SEWAGE DISPOSAL SYSTEM

SUBDIVISION Upper Trail ROAD 16394 Old Frederick Rd LOT 17

RE: Building Permit Application
Number: B00112824
16394 Old Frederick Road

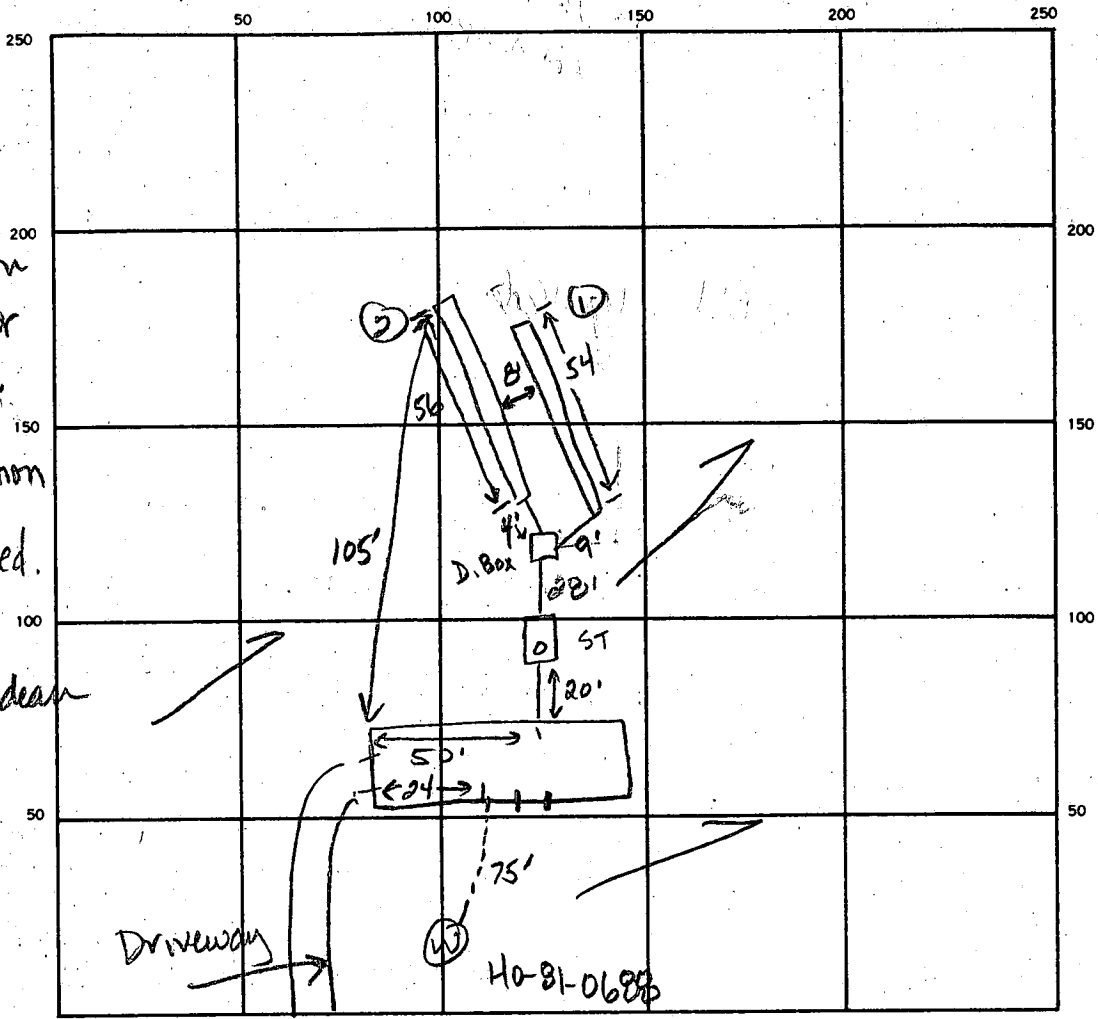
12-16-87
 WP Inspection
 Pitless adaptor
 at 39 inches,
 well line and
 house connection
 covered. No
 tank installed.
 Well line is
 through the
 wall. JENadeau

REMARKS 12-16-87 ok to add stone, pipe & paper to trenches. ok to cover all trenches and all other work. Trenches had 50% to 80% weathered, decomposed shale in them. JEN

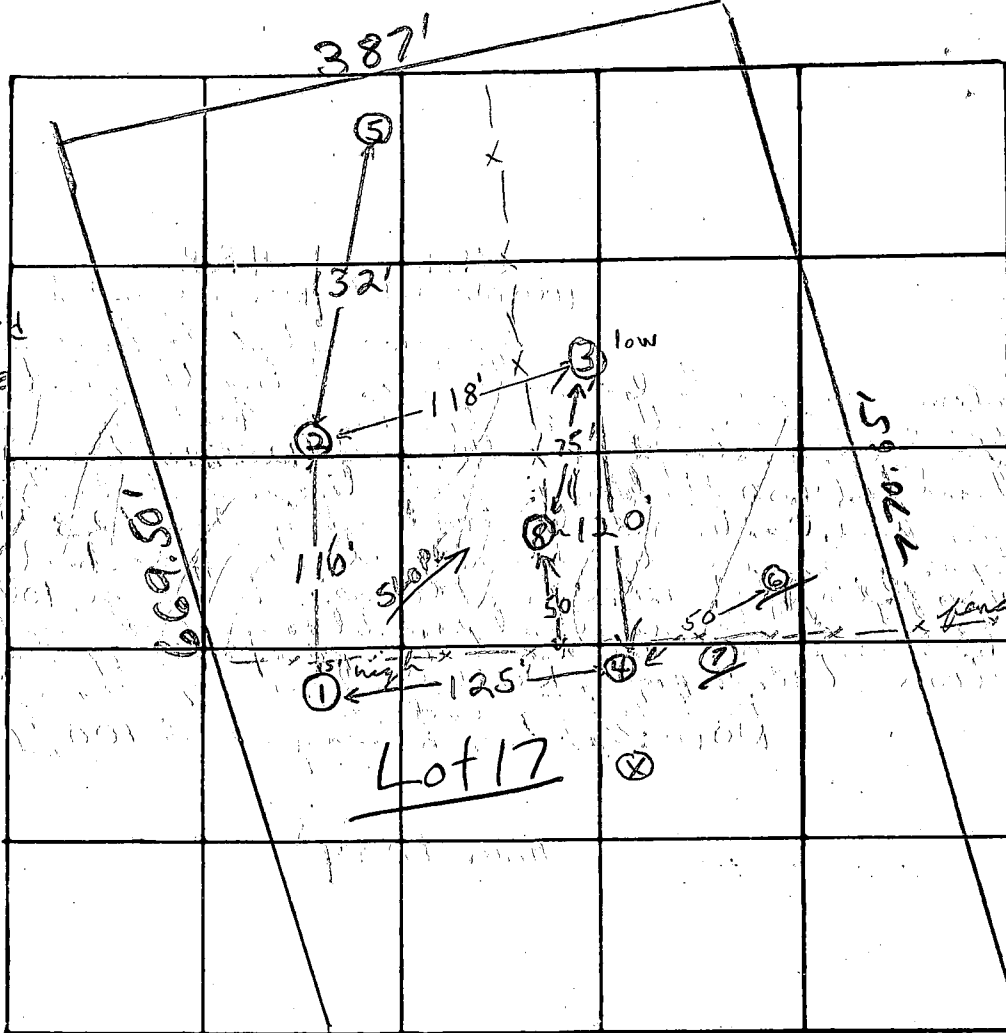
REMARKS 8 11 1/2' clayey to 2' silty, weathered saprolite below
 Certify hole location. Max. Depth 6 ft!

TYPE OF SOIL clayey 1-3', silty, weathered saprolite below; Rocky ④, ⑥, ⑦
